Addendum No.: 02

June 10, 2019

CT DAS ● Construction Services ● Office of Legal Affairs, Policy, and Procurement

SCSU Residence Hall Shelf Angle Repairs SCSU, New Haven CF-RS-358

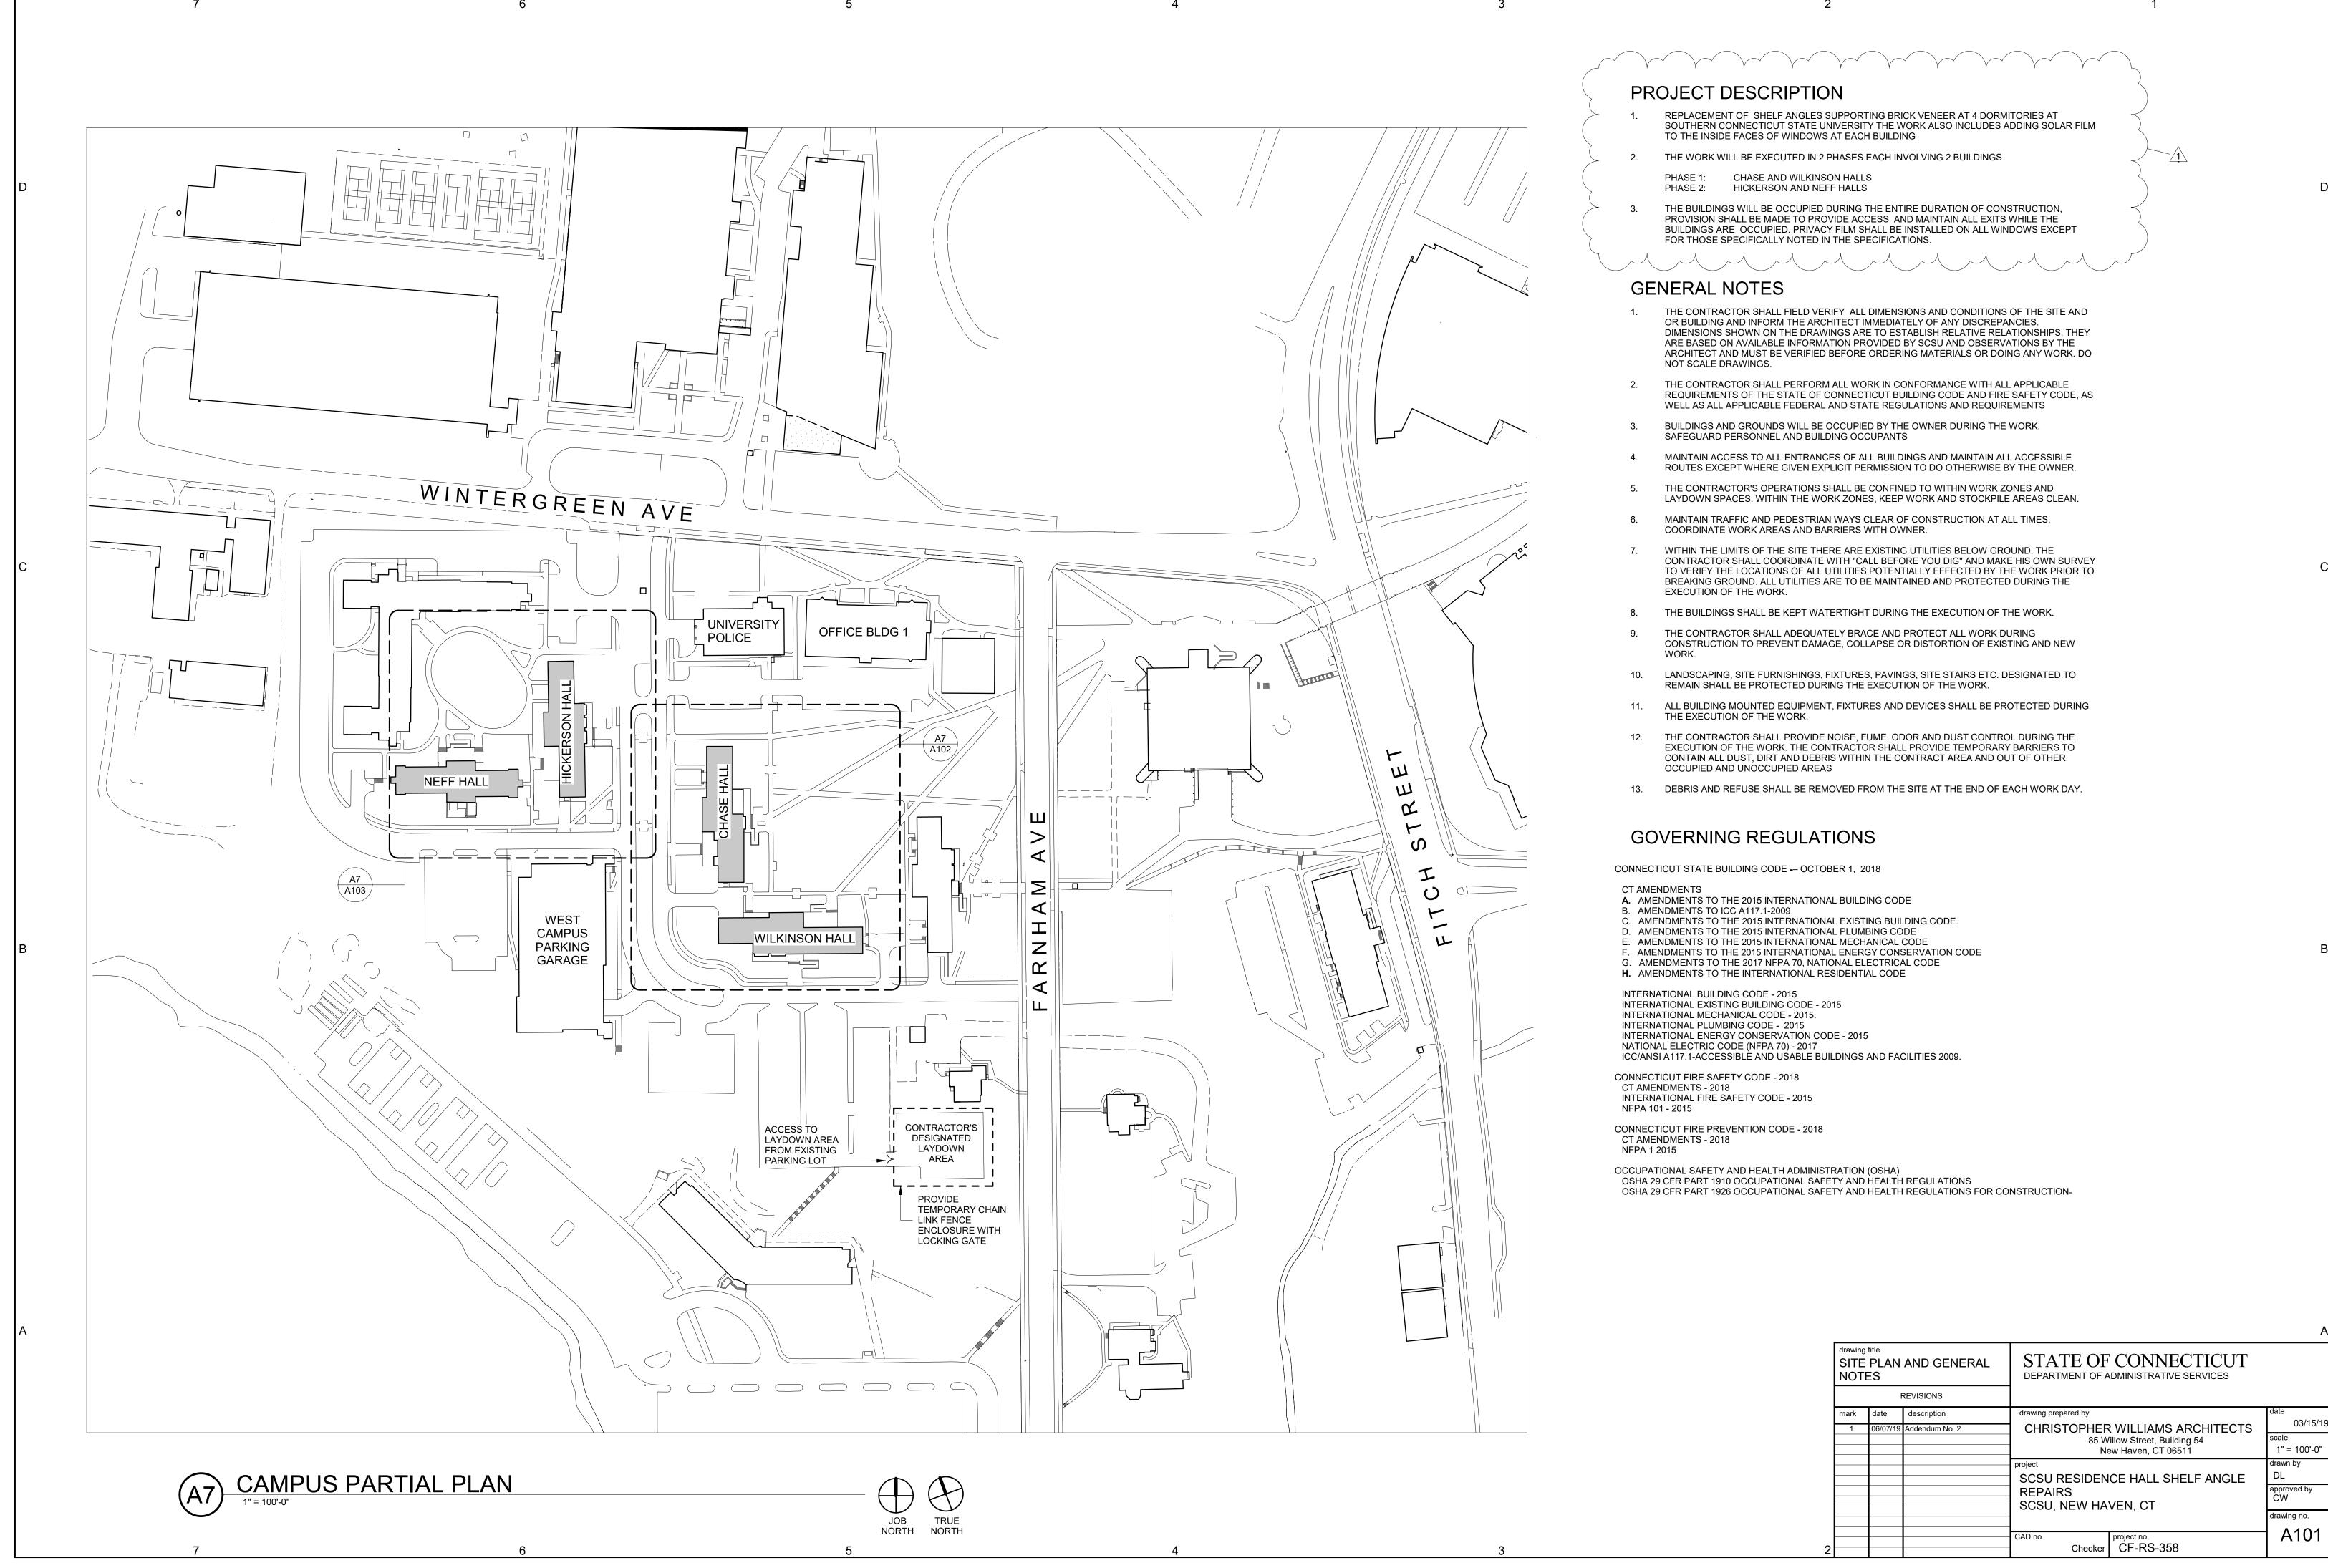
RFI Question: On Drawing A101 the Project Description overlaps the "General Notes". Some information may be missing

Response: See Addendum 02 Sheet A101 for correction

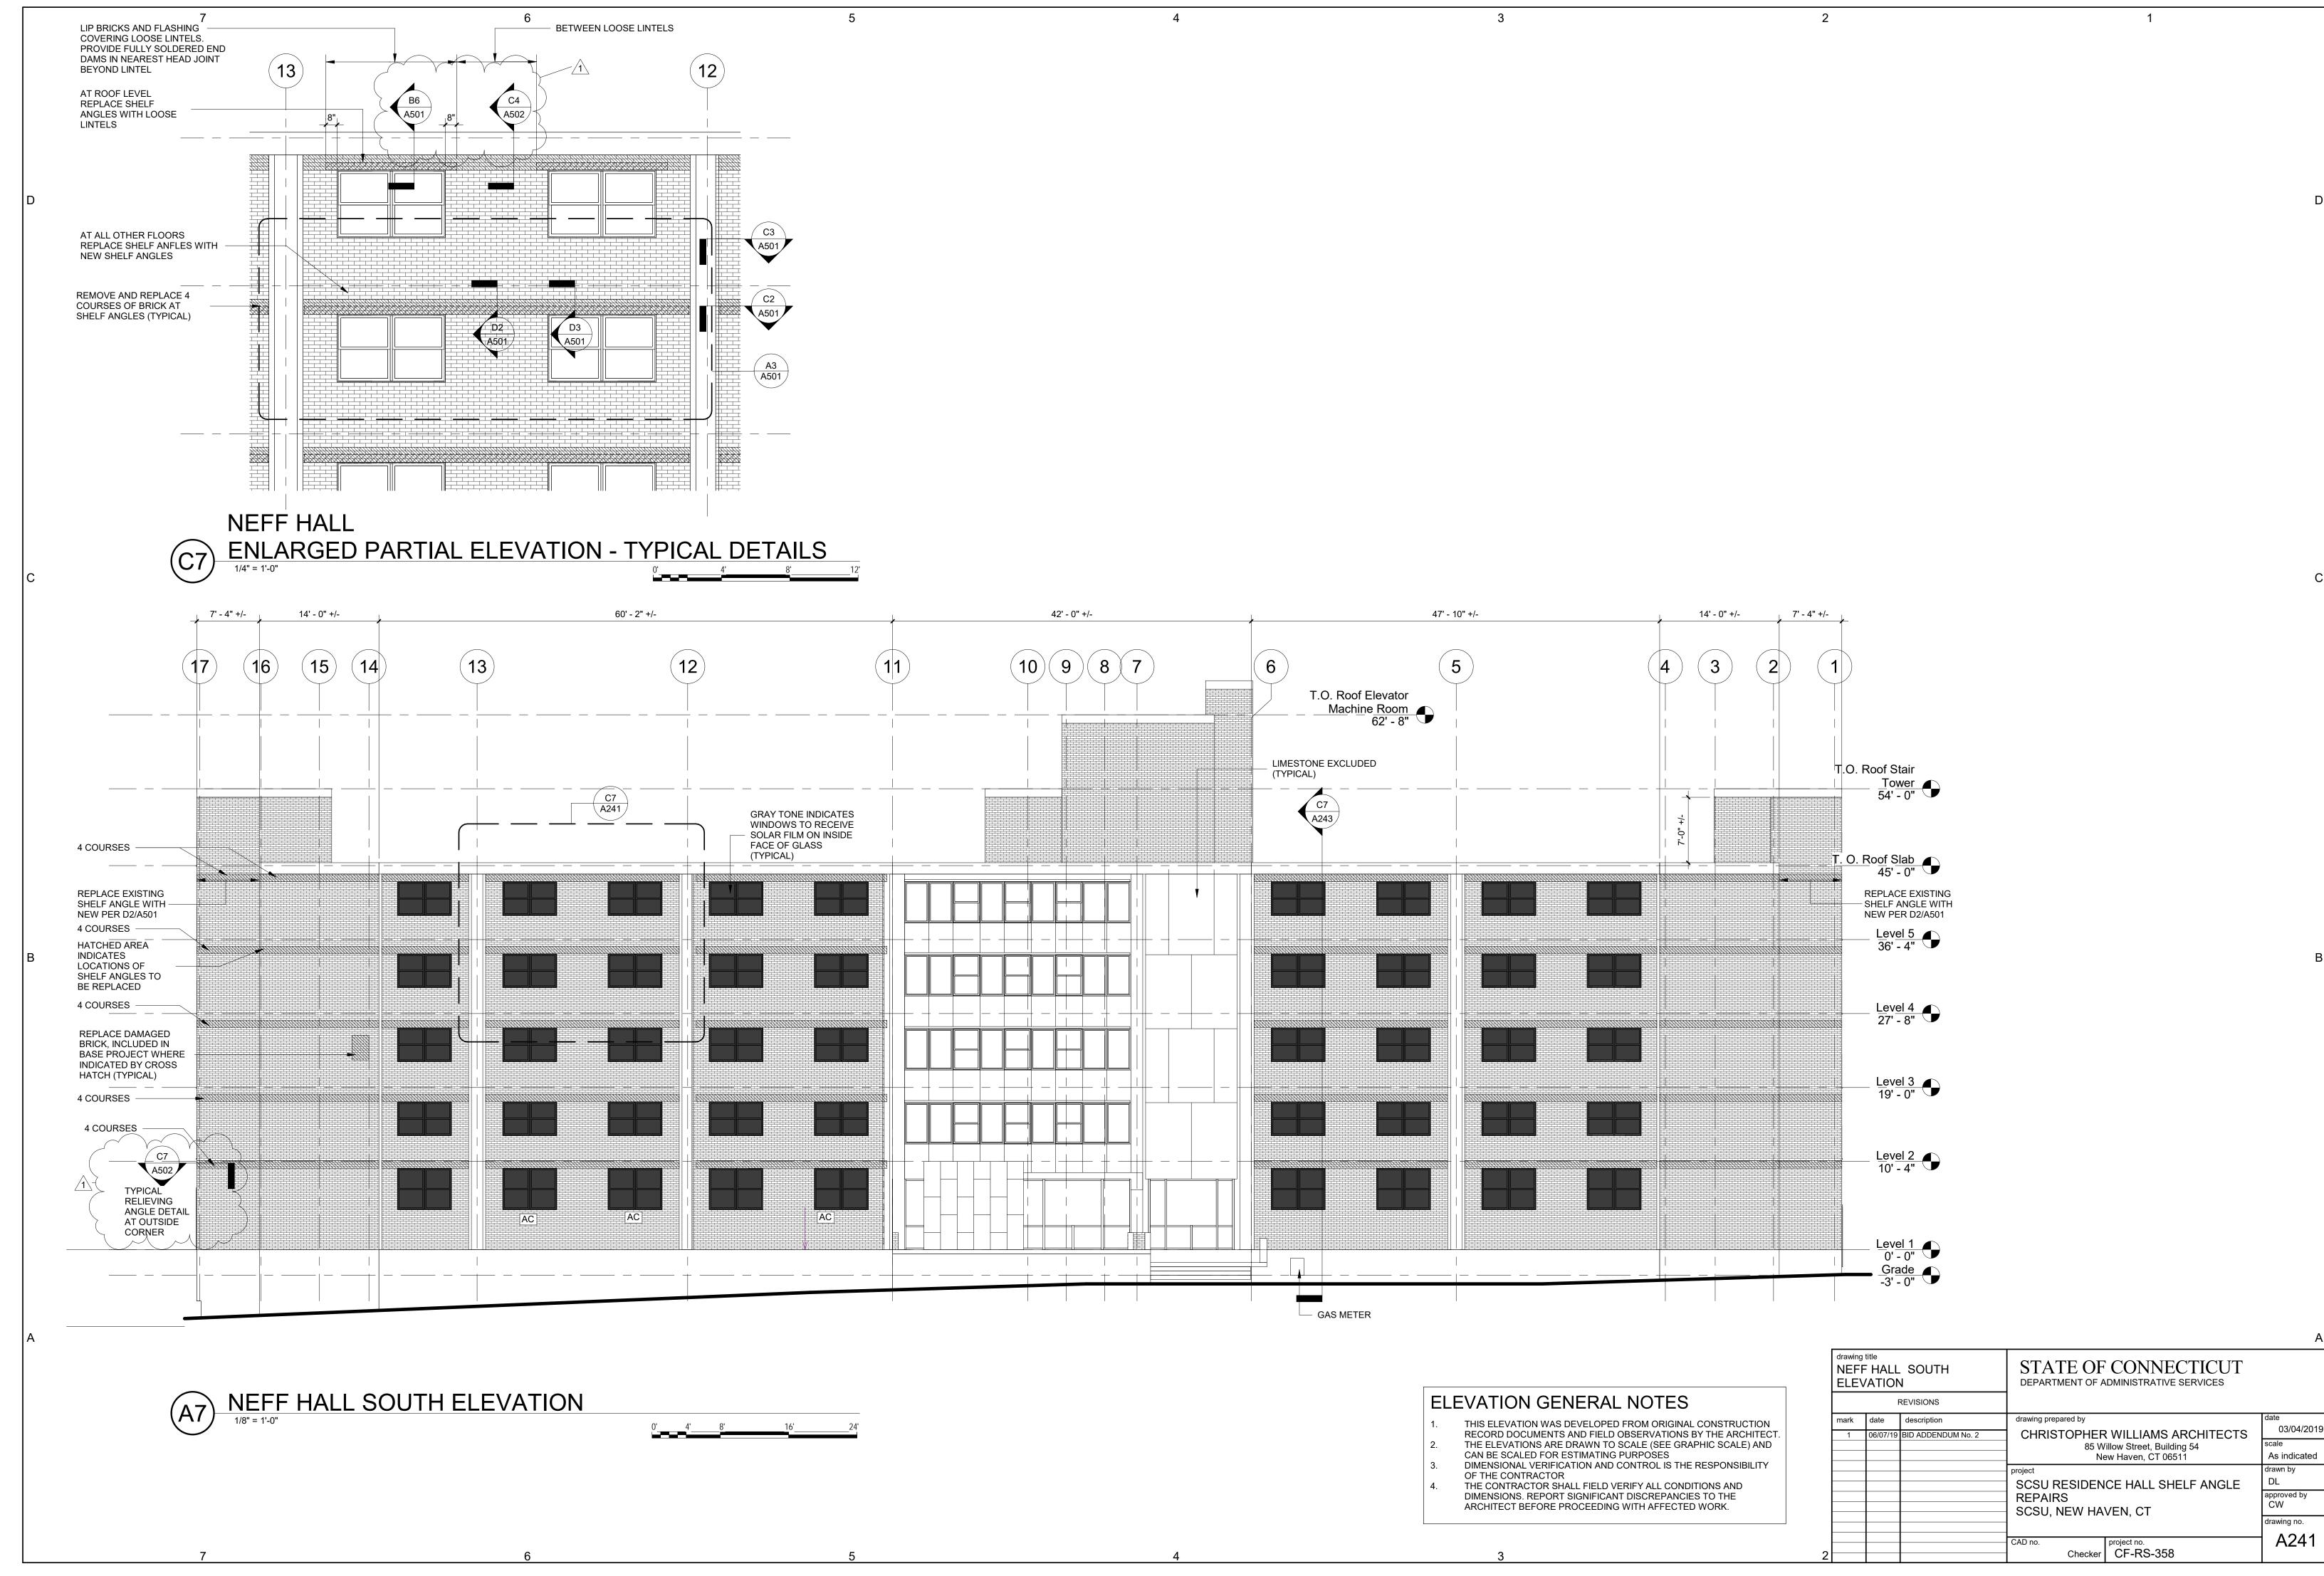
RFI Question: Wall Detail C7/A241 shows Detail A6/A501 at the roof level. This is the outside corner detail. Please review.

Response: The detail in question was incorrectly identified. This has been corrected on Addendum 02 Sheet A241
